ESV Validation Report

Powercor 2017-2018
Fire Start Report
Final Report

Figure 1: The location of incident 20180129PWA_02 relative to the location area boundary

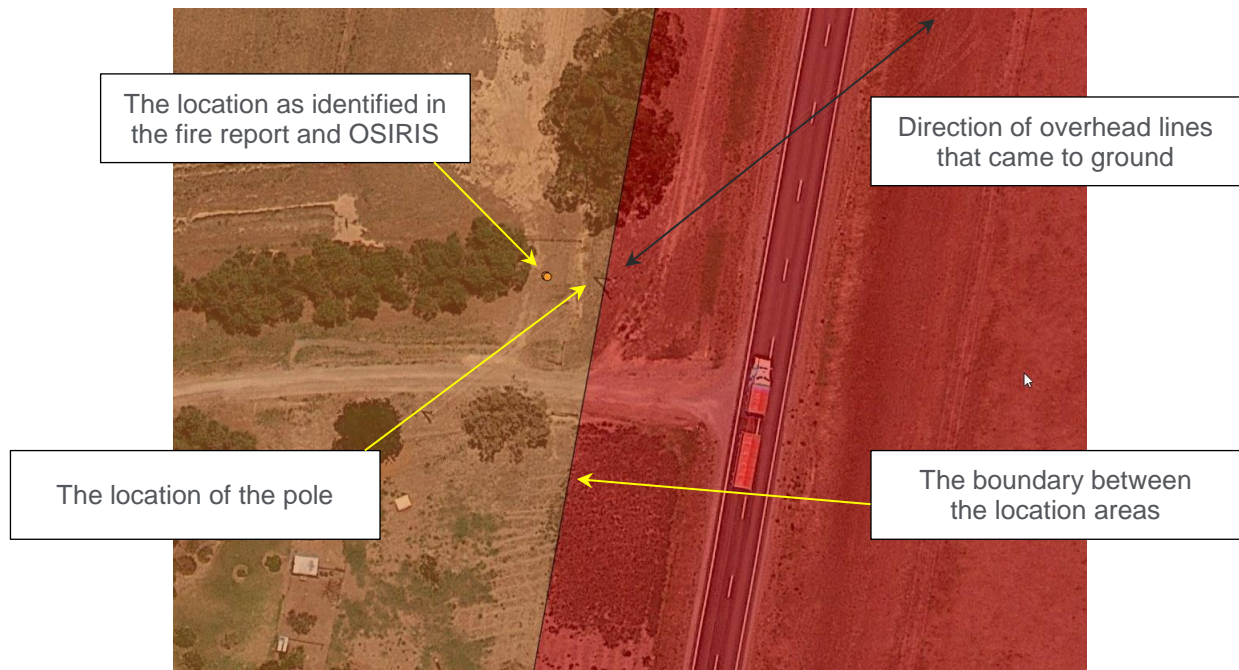
OSIRIS report	Amend OSIRIS	Amend fire start report	ESV and Powercor commentary
20171031PWA_01	Yes	No	<p>There is a significant difference in the locations listed in the fire start report and OSIRIS. The two locations are approx. 1 km apart. The issue is that a tree falling across the powerlines at the OSIRIS location caused a HV fuse failure and fire at the fire start report location.</p> <p>OSIRIS was amended to reflect the address and location in the fire report as this is the reportable event. The description in OSIRIS was updated to include the address and coordinates for the originating event.</p>
20180129PWA_02	No	No	<p>The location of the pole listed in the fire start report is in an area designated "within area delineated on plan LEGL./16-354" rather than the higher risk zone listed in the fire start report (Figure 1).</p> <p>Powercor advised that, while the pole that was impacted lies in the lower risk zone, the cable that came to ground crossed the road and into the higher risk zone. The point at which the fire occurred was in the higher risk zone. Figure 2 shows the location of the fire relative to the pole that was impacted by the vehicle.</p>
